PROPOSED IMPROVEMENT TOWN OF SPRINGFIELD COUNTY OF WINDSOR SPRINGFIELD TRANSPORTATION PATH STP BIKE(23)S

DuBois & King
engineering
planning
management
development
PROJECT: SPRINGFIELD STP BIKE(23)S
PROJECT: SPRINGFIELD TRANSPORTATION PATH
PROJECT: N13548F2
SHEET 1

RECORD
DRAWINGS

AGGREGATE BIKE PATH

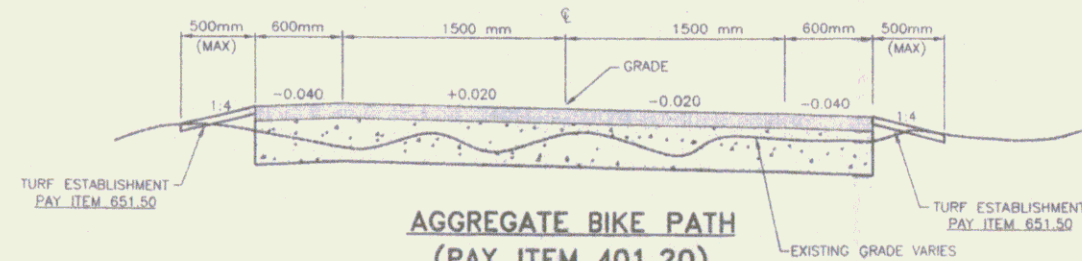
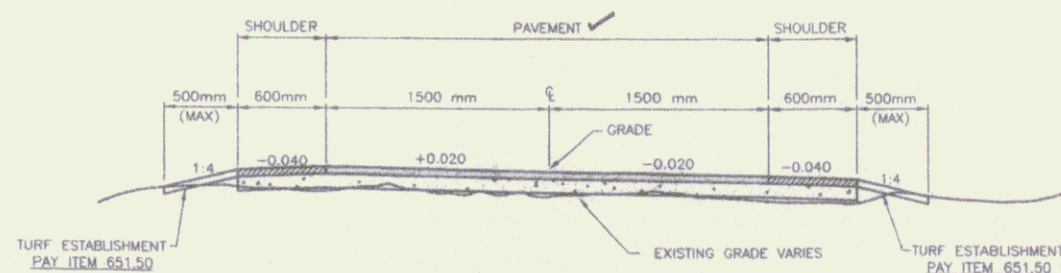
BY GURNEY BROTHERS CONST. INC. FOR TOWN OF SPRD.

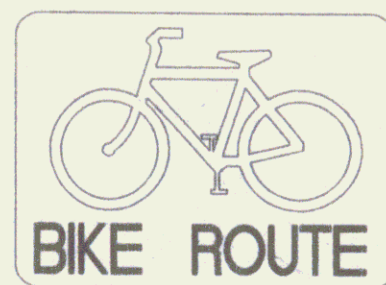
Add Sign - "Trailhead Parking"

SPRINGFIELD TRANSPORTATION PATH
PHASE 1
TOWN OF SPRINGFIELD
SPRINGFIELD, VERMONT
KIOSK DETAILS

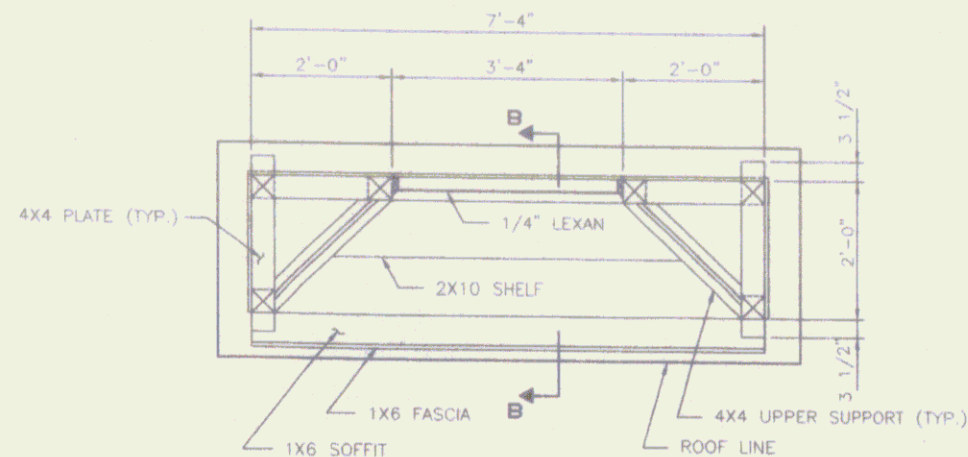
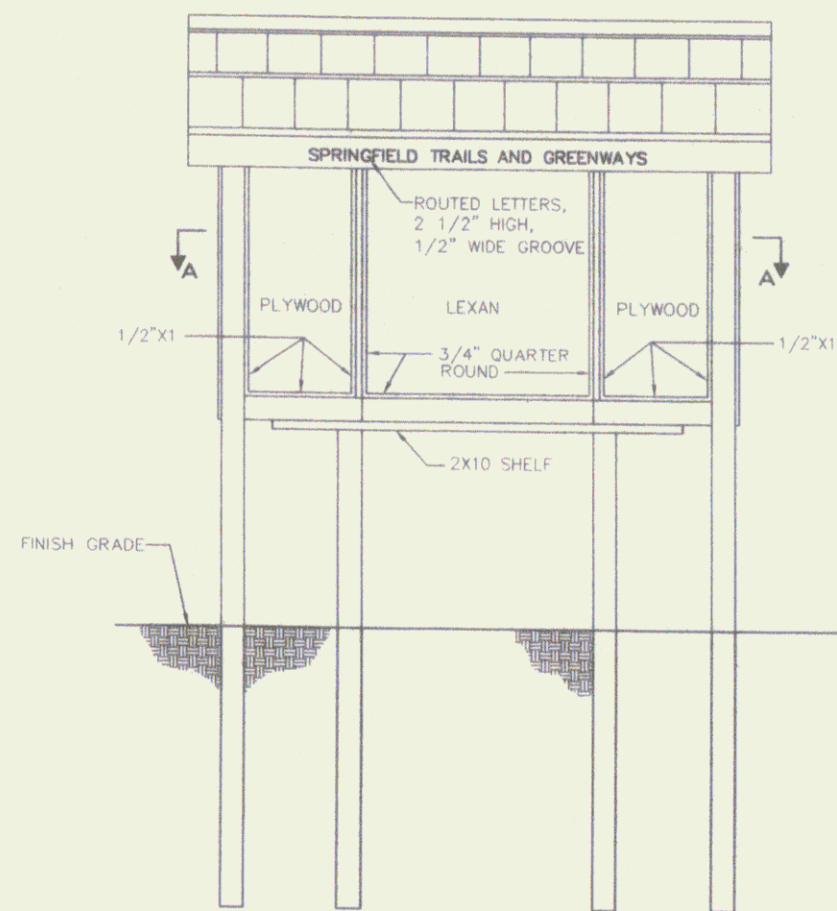
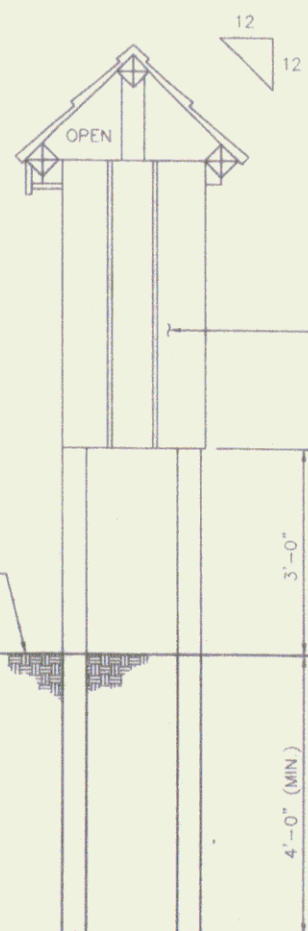
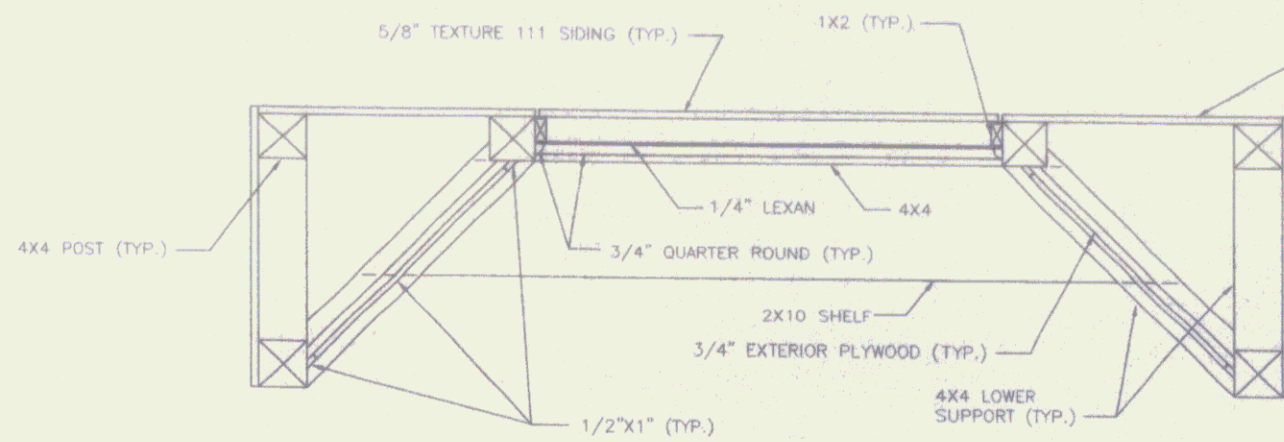
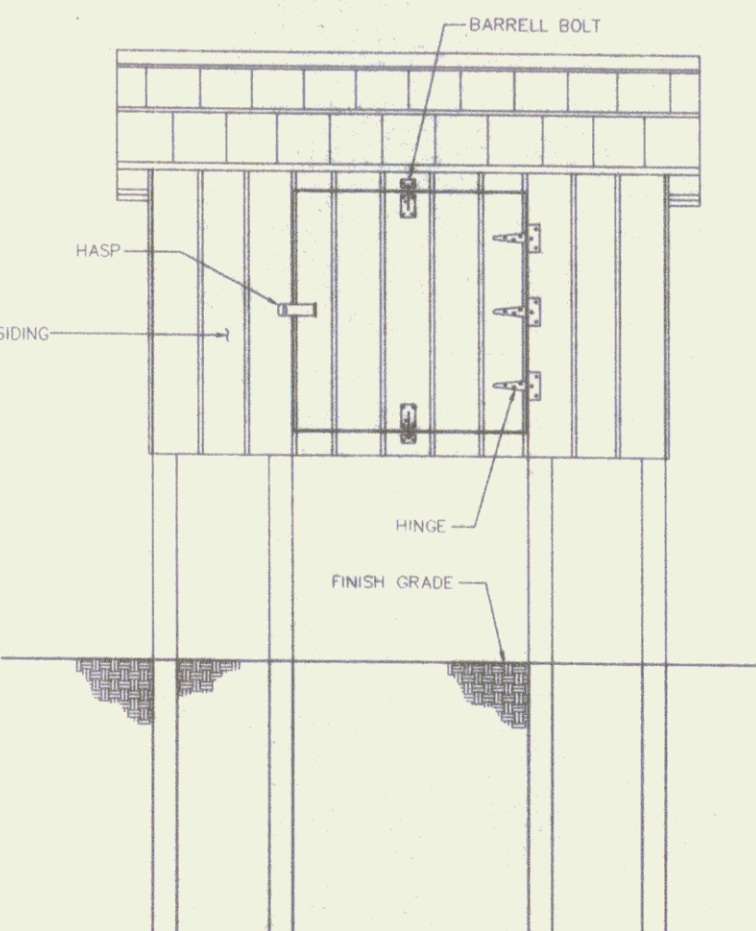
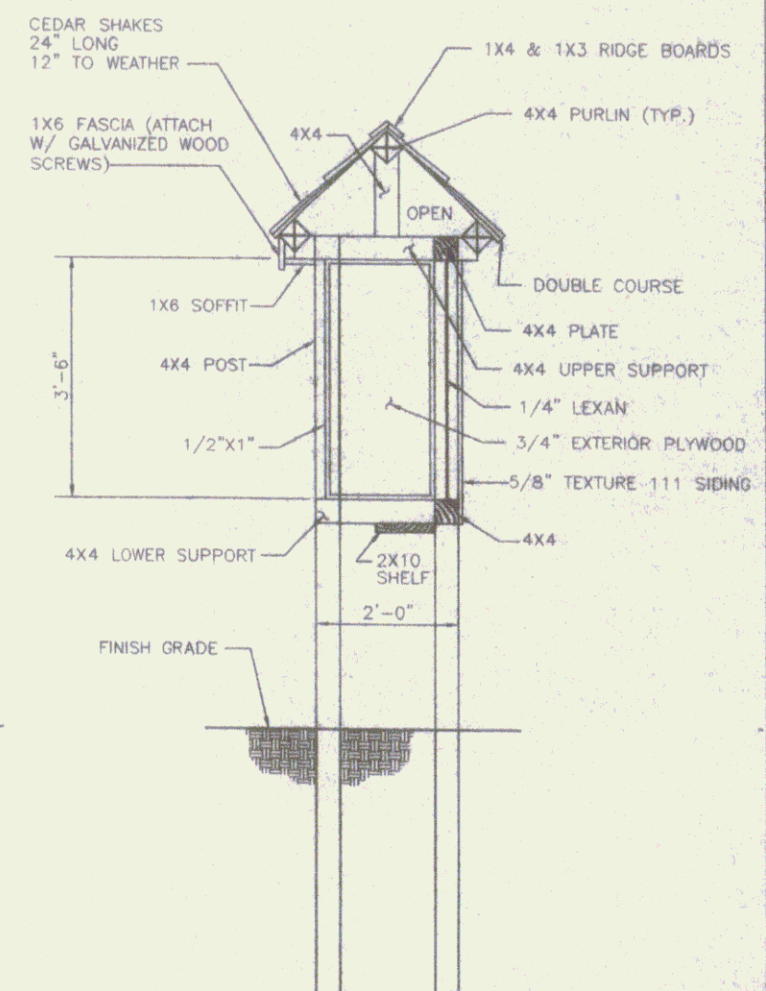
*N. I. C.
Constructed by
Crown Point Builders
Set by J. P. Sicard Inc.*
